Palo Verde Nuclear
Generating Station

**Subject: Palo Verde Nuclear Generating Station (PVNGS)
Units 1, 2, and 3
Docket Nos. STN 50-528, 50-529 and 50-530
Response to September 30, 2009, Request for Additional Information
Regarding Severe Accident Mitigation Alternatives for the Review of
the PVNGS License Renewal Application, and License Renewal
Application Amendment No. 2**

**Response to September 30, 2009, Request for Additional Information
Regarding Severe Accident Mitigation Alternatives for the Review of
the Palo Verde Nuclear Generating Station License Renewal
Application**

Figure 2.d-1: Non-Station Blackout Level 2 Event Tree

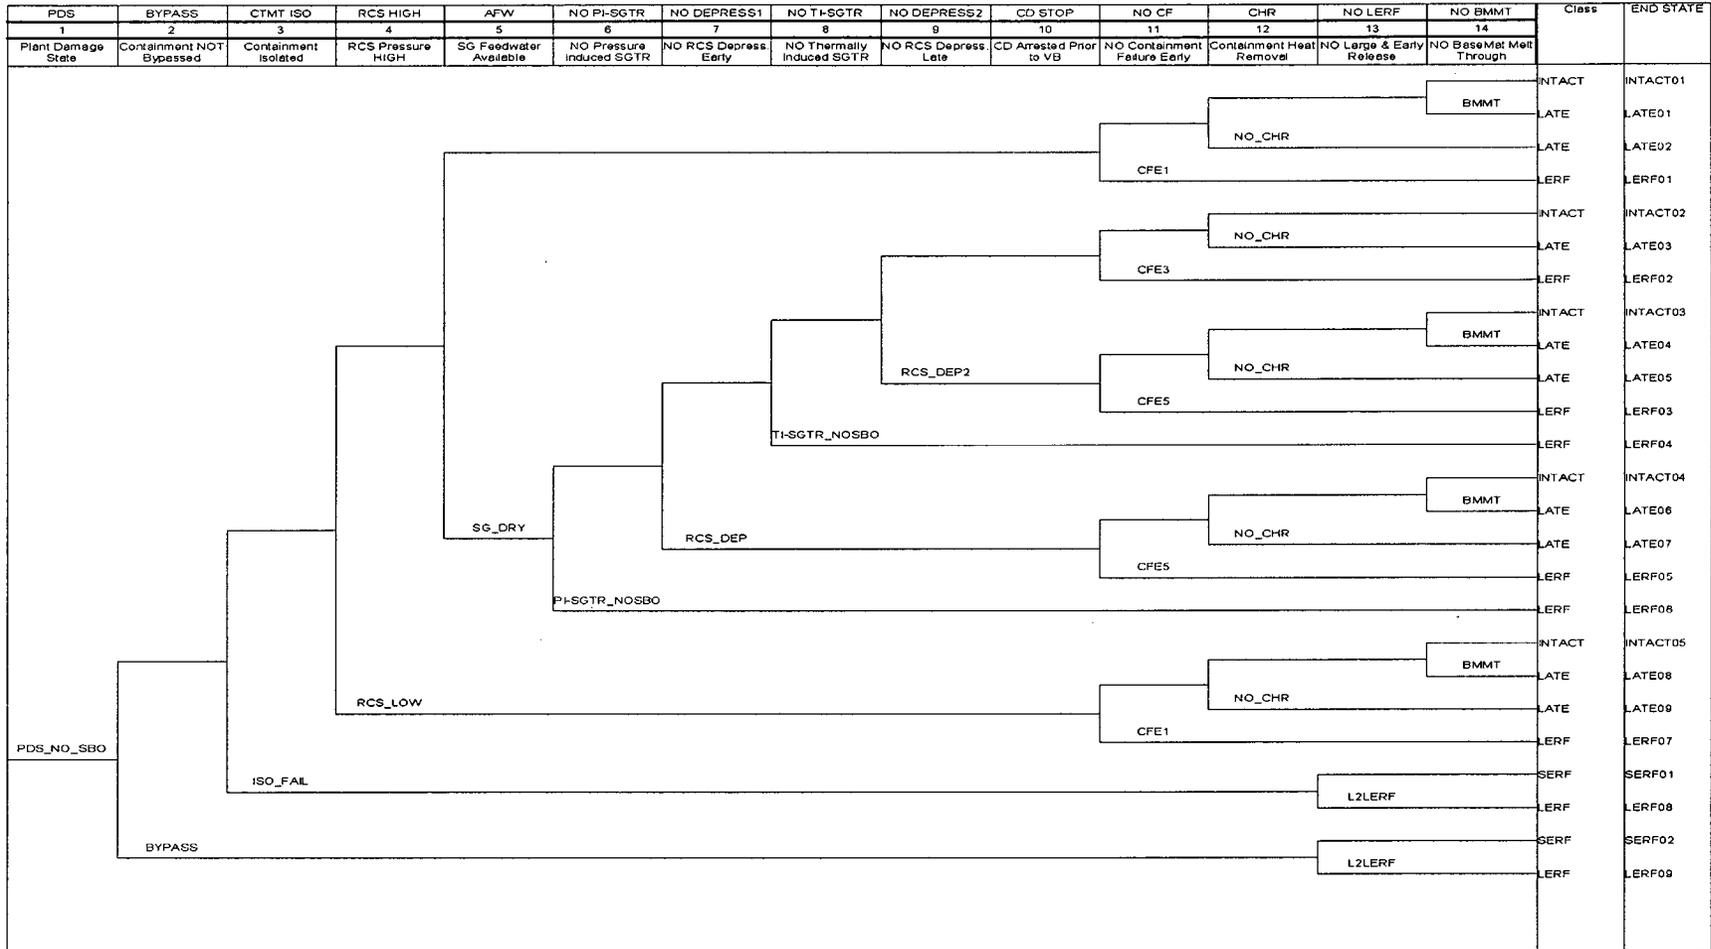
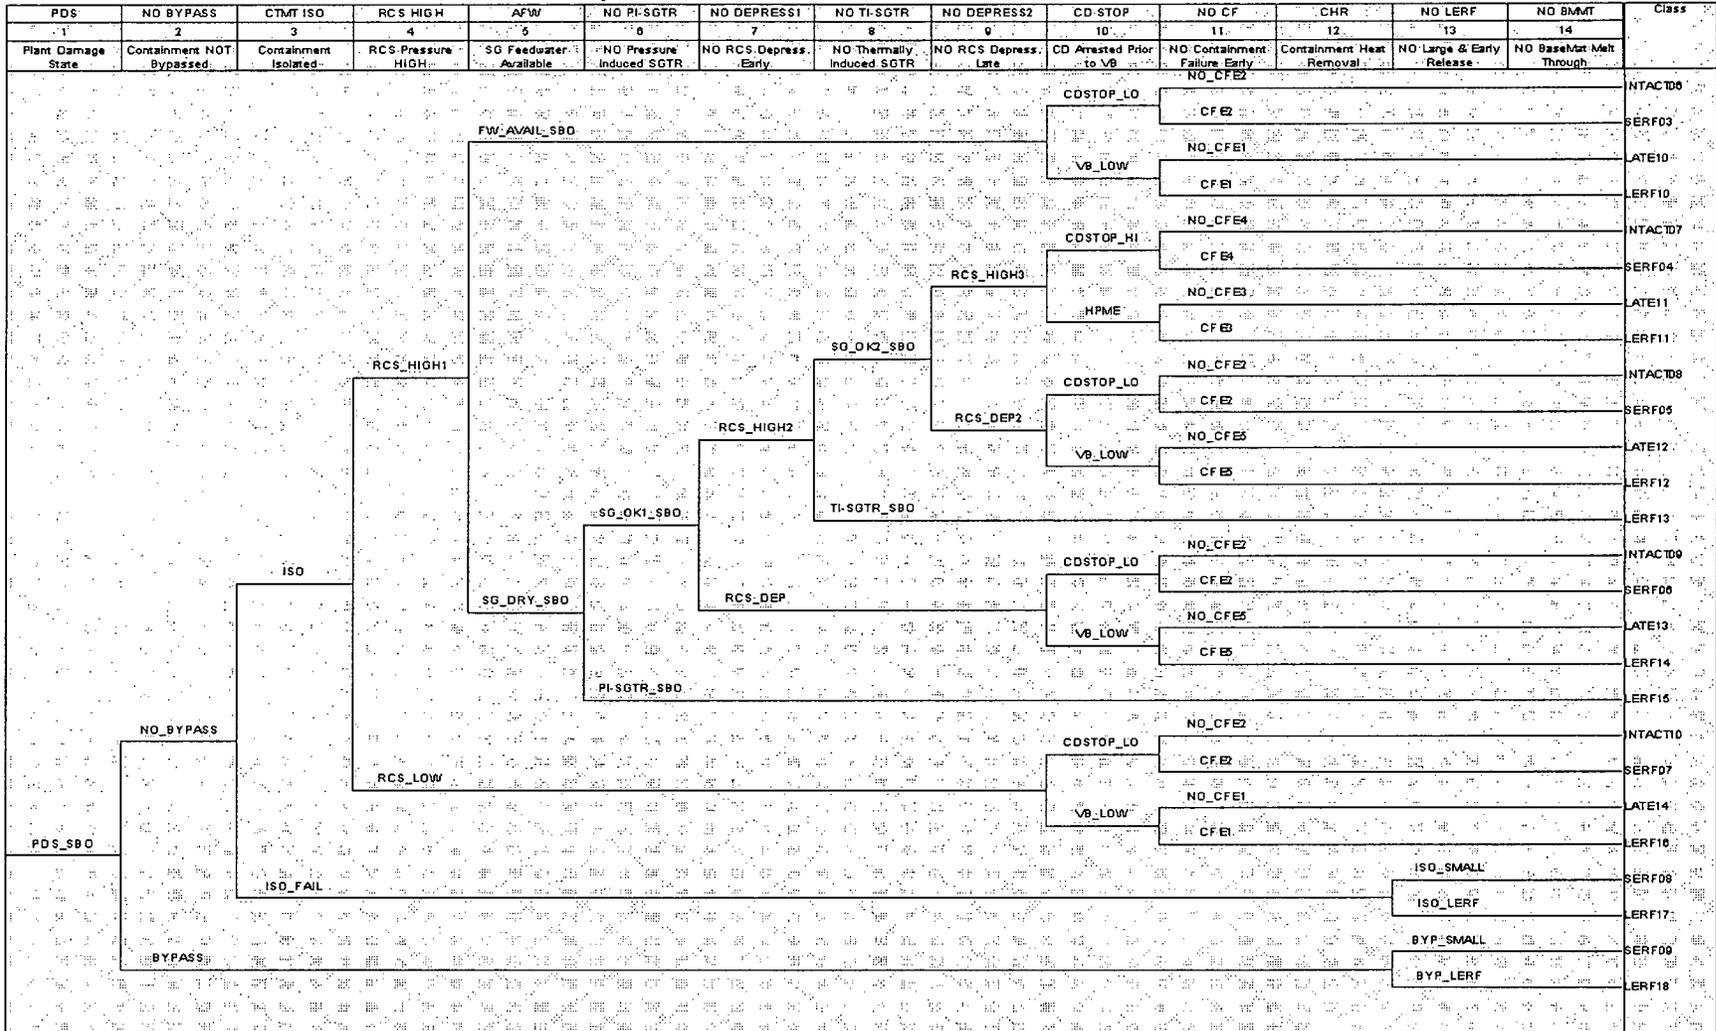
Provide a description of the process used to group the containment event tree (CET) end states into release categories. Identify the number of CETs developed for the Level 2 analysis and describe how they correlate to release categories and plant damage states. Provide a typical CET showing release categories assigned to each end state.

The PVNGS Level 2 fault tree structure was developed using the containment event tree structure from Westinghouse document WCAP-16341-P (Ref. WEST 2005 in ER Section D.11). The event tree structures are provided below in Figures 2.d-1 and 2.d-2. Figure 2.d-1 shows the non-station blackout (SBO) event tree and Figure 2.d-2 shows the SBO event tree.

Each sequence through the containment event tree results in a unique endstate. Each endstate is from one of four categories: (1) intact, (2) large early release (LERF), (3) small early release (SERF), or (4) late. The endstates are then sequentially numbered.

Figure 3.b-1

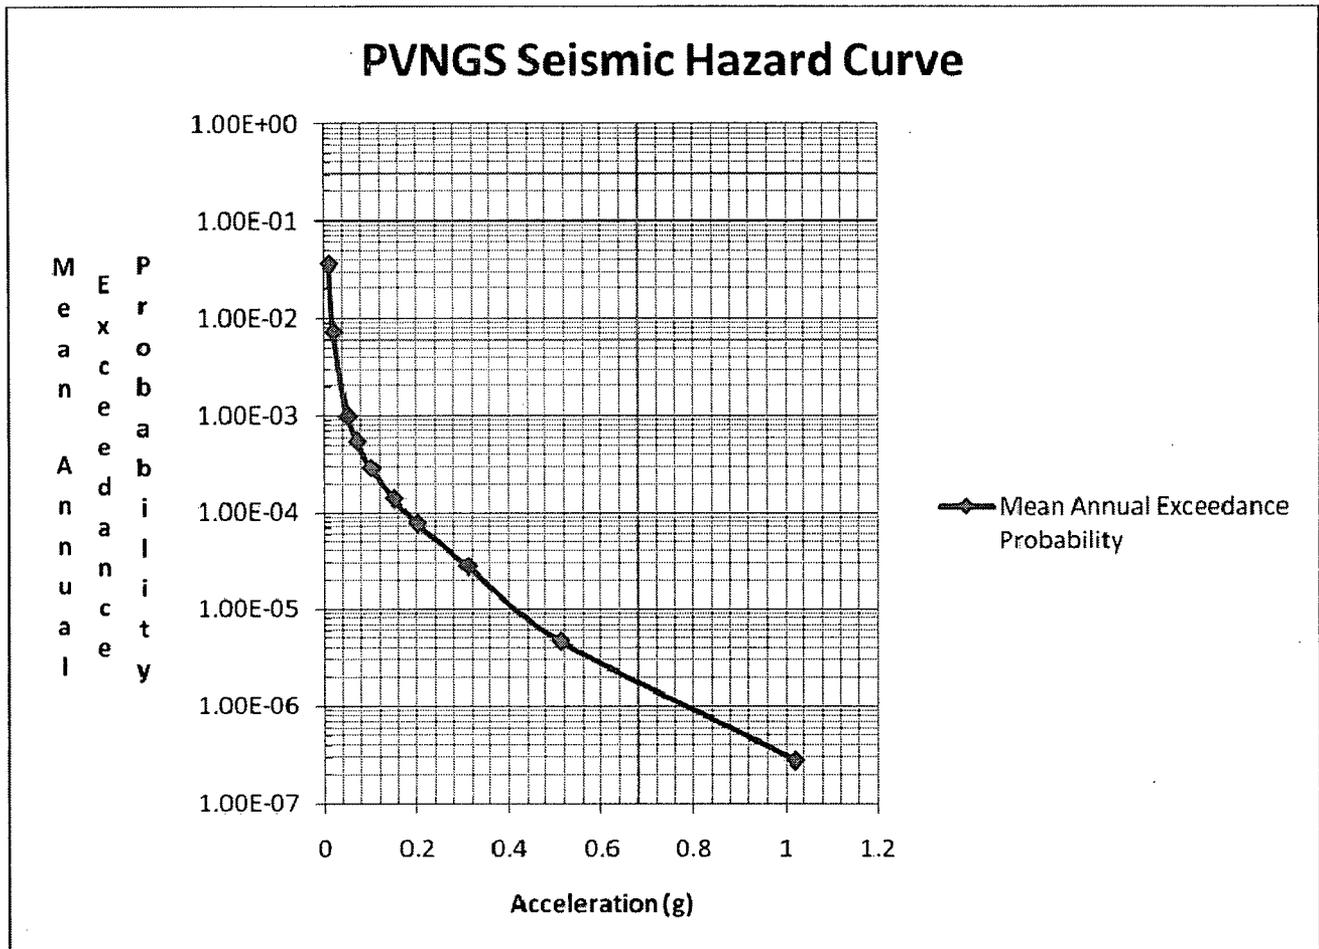
Program” (Arizona Public Service Company [APS] Letter to NRC #102-05902-JHH/DFS, dated October 1, 2008), APS estimated the seismic CDF for PVNGS to be about $7.49E-06$ per year using the approximation method described in a paper by Robert P. Kennedy, “Overview of Methods for Seismic PRA and Margin Analysis Including Recent Innovations,” and using seismic hazard curve data for Palo Verde. Based on this, provide justification for why a multiplier of 3.6 $[(5.72E-06 + 7.49E-06) / 5.07E-06 + 1]$ shouldn't be used to account for the additional risk of all external events (seismic, fire, high winds, etc.) rather than the multiplier of two used in the SAMA analysis.

Upon review, it was concluded that the method used to estimate the “hazard exceedance frequency” ($H_{10\%}$) in APS letter no. 102-05902-JHH/DFS was slightly conservative. Specifically, the use of linear interpolation to estimate $H_{10\%}$ for a non-linear curve resulted in an increased value for $H_{10\%}$. When the available data points for the Palo Verde seismic hazard curve are plotted, as shown in Figure 3.b-1 below, it can be seen that a value of $9.50E-06$ for the 0.42g acceleration is a more realistic fit to the existing data than the value of $1.50E-05$ shown in Table B-1 on page B-3 in APS letter no. 102-05902-JHH/DFS.

When 9.50E-06 is used in place of 1.50E-05, the seismic CDF is reduced to 4.75E-06/yr:
